The Commission has issued the enclosed Amendments Nos. 102, 102, and 99 to Licenses Nos. DPR-38, DPR-47 and DPR-55 for the Oconee Nuclear Station, Units Nos. 1, 2 and 3. These amendments consist of changes to the Station's common Technical Specifications (TSs) in response to your applications dated September 8 and September 10, 1981.

These amendments revise the TSs to reflect current calculated string errors used in the determination of Reactor Protective System setpoints and upgrade the format of the Operational Safety Instrumentation Table.

SAFETY EVALUATION BY THE OFFICE OF NUCLEAR REACTOR REGULATION

OCONEE NUCLEAR STATION, UNITS NOS. 1, 2 AND 3

Figure 2.1-2C

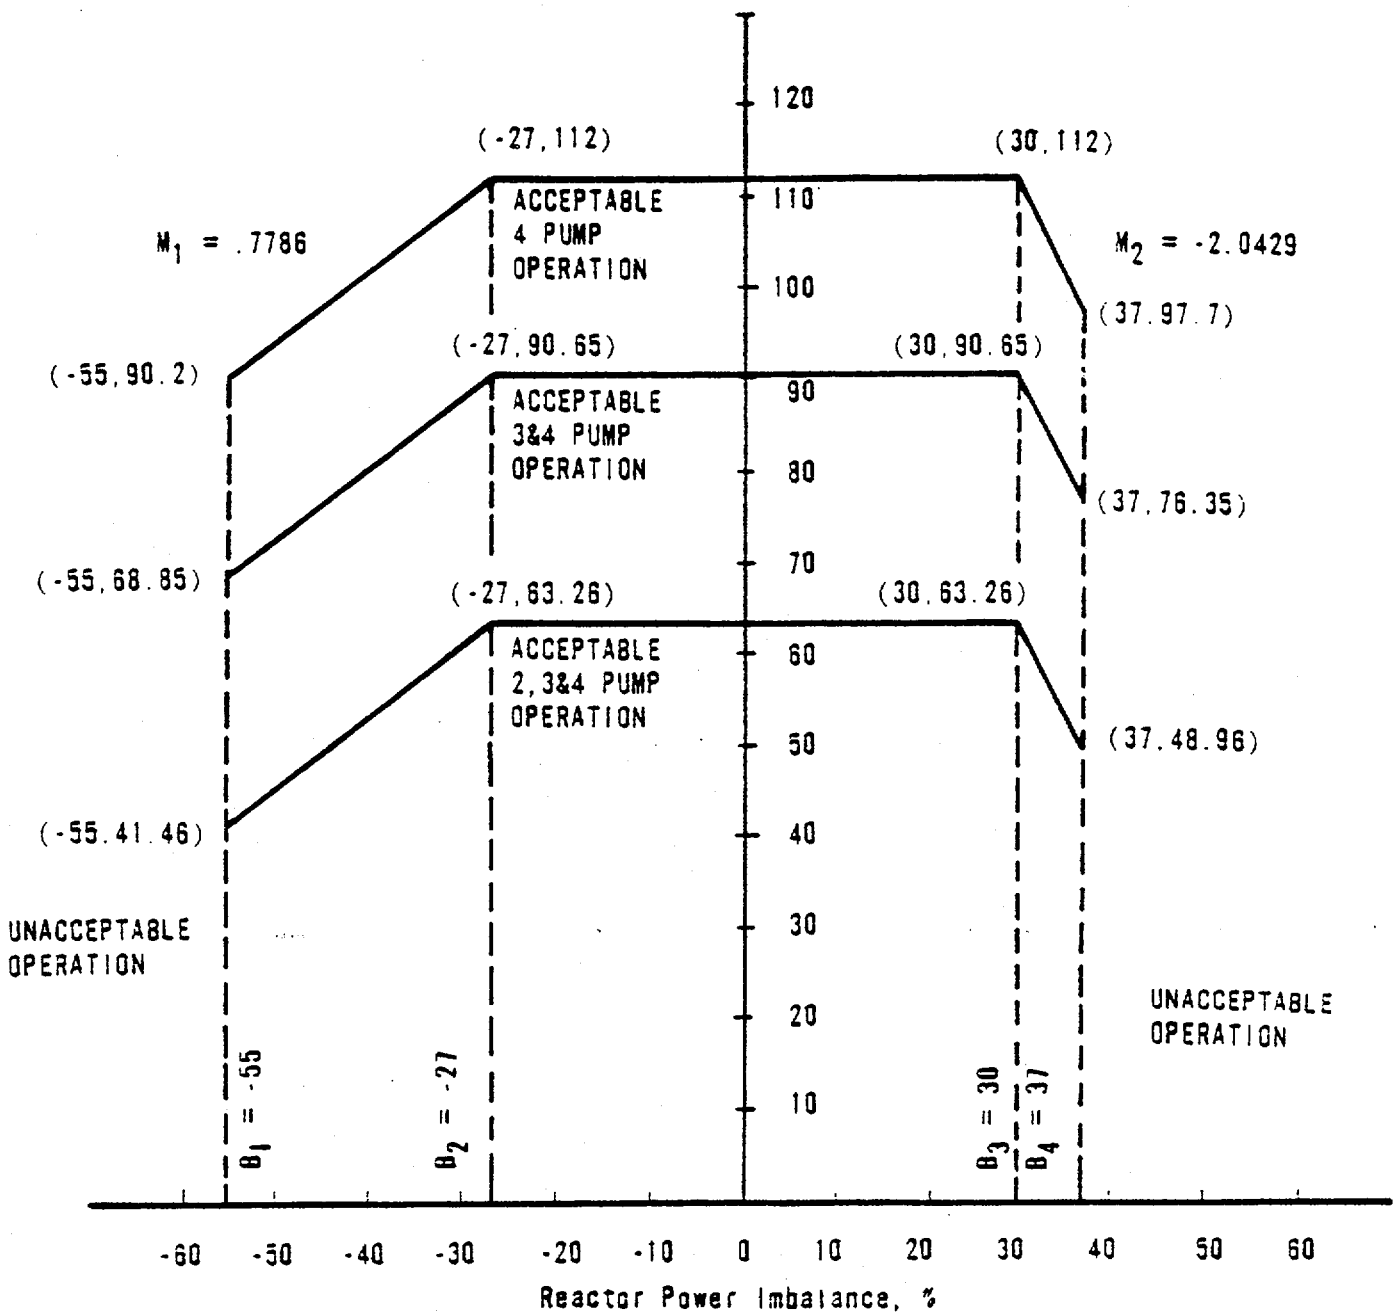
The specified flow rates for Curves 1, 2 and 3 of Figure 2.1-2C correspond to the expected minimum flow rates with four pumps, three pumps and one pump in each loop, respectively.

The changes to Section 2.1 and the Protective System Maximum Allowable Setpoints in Section 2.3 were calculated for Oconee Unit 3 and apply only to that Unit. Similar changes will be incorporated in the reload applications for Oconee Units 1 and 2.

Figure 2.1-3C

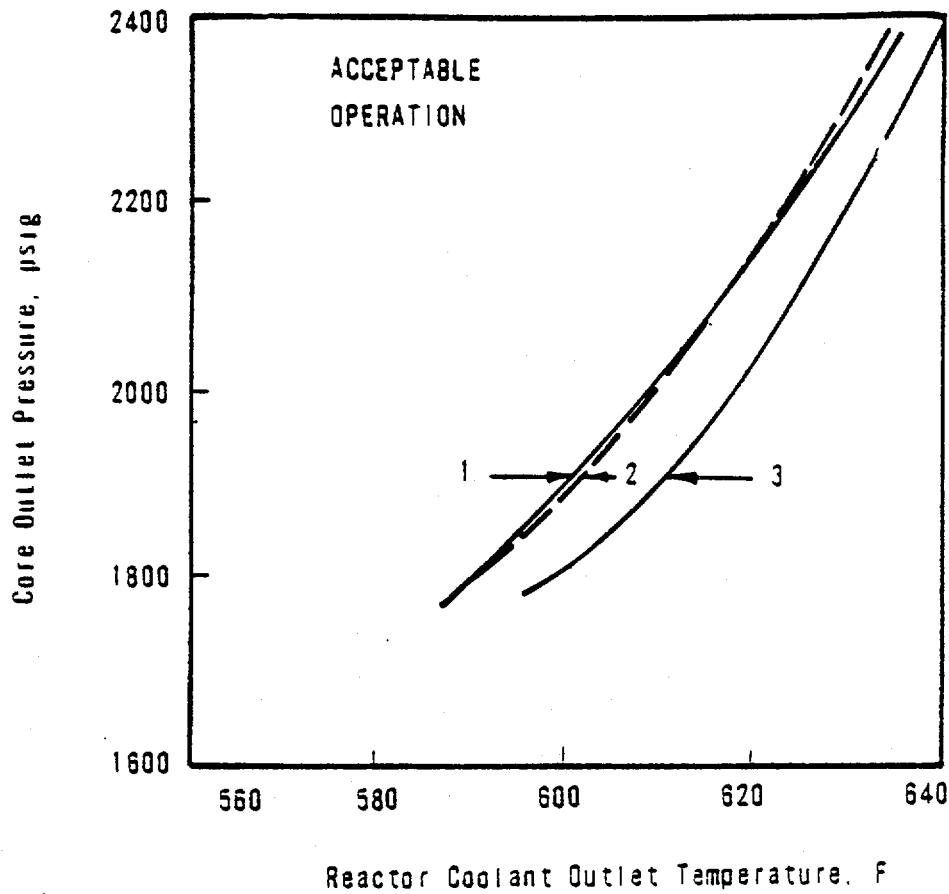
For each curve of Figure 2.1-3C a pressure-temperature point above and to the left of the curve would result in a DNBR greater than 1.30 or a local quality at the point of minimum DNBR less than 22 percent for that particular reactor coolant pump situation. The curve of Figure 2.1-1C is the most restrictive of all possible reactor coolant pump-maximum thermal power combinations shown in Figure 2.1-3C.

Figure 2.3-2C

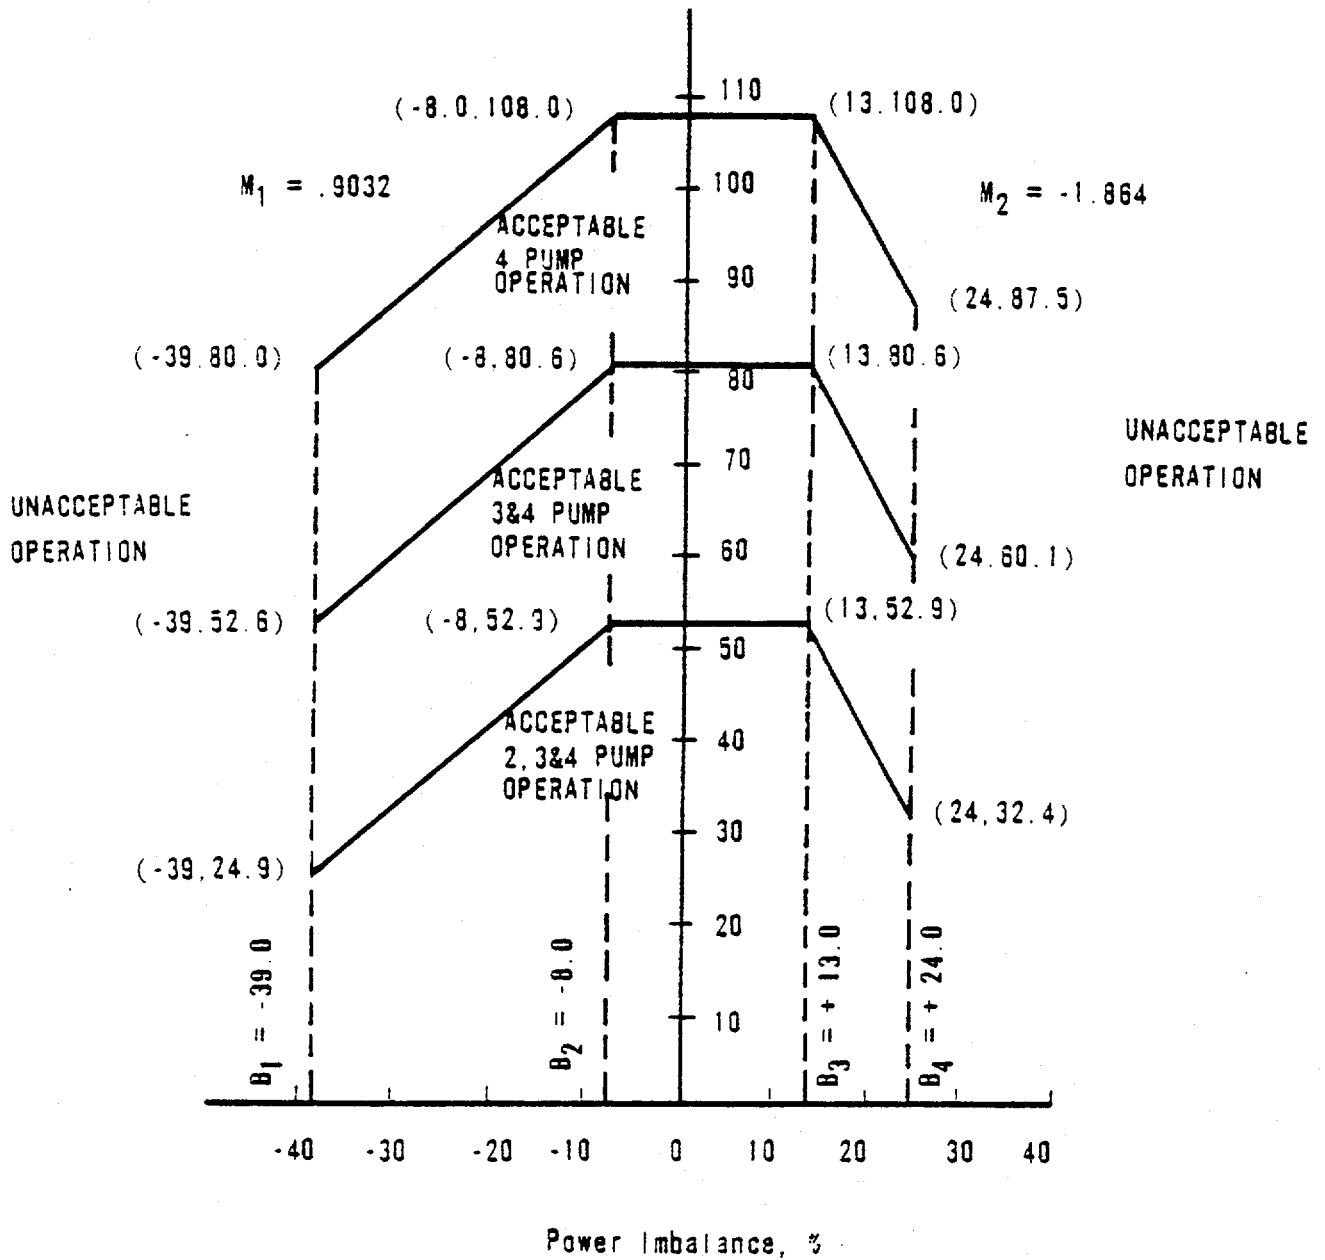
The power-imbalance boundaries are established in order to prevent reactor thermal limits from being exceeded. These thermal limits are either power peaking kw/ft limits or DNBR limits. The reactor power imbalance (power in the top half of core minus power in the bottom half of core) reduces the power level trip produced by the power-to-flow ratio such that the boundaries of Figure 2.3-2A - Unit 1 are produced. The power-to-flow ratio reduces the power
